MODIFICATIONS TO ELECTRICAL SHEETS

TOWN OF ADDISON, TEXAS

ADDISON ROAD IMPROVEMENTS
BELT LINE ROAD TO ARAPAHO ROAD PHASE I
ELECTRICAL MODIFICATION NOTES

STREET LIGHT BASE

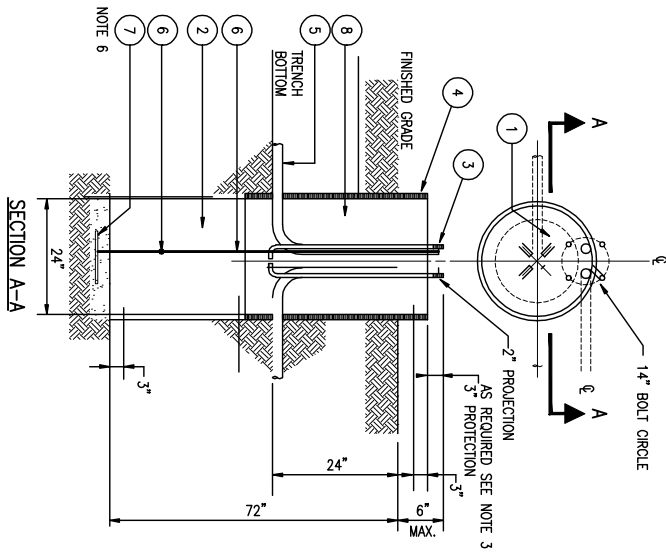
- E. Sheet No. 66 (Drawing E-5): Details.
 1. Modify detail 3/E-5 height currently indicated for the pole as 38'-0" to 17'-0".
 2. Detail (3/E-5) Fixture SAA add the following:
 "For combination roadway/pedestrian type SA fixture, the light fixture and obstruction light will both be served from the pedestrian lighting circuit and be controlled by the obstruction light photo cell."
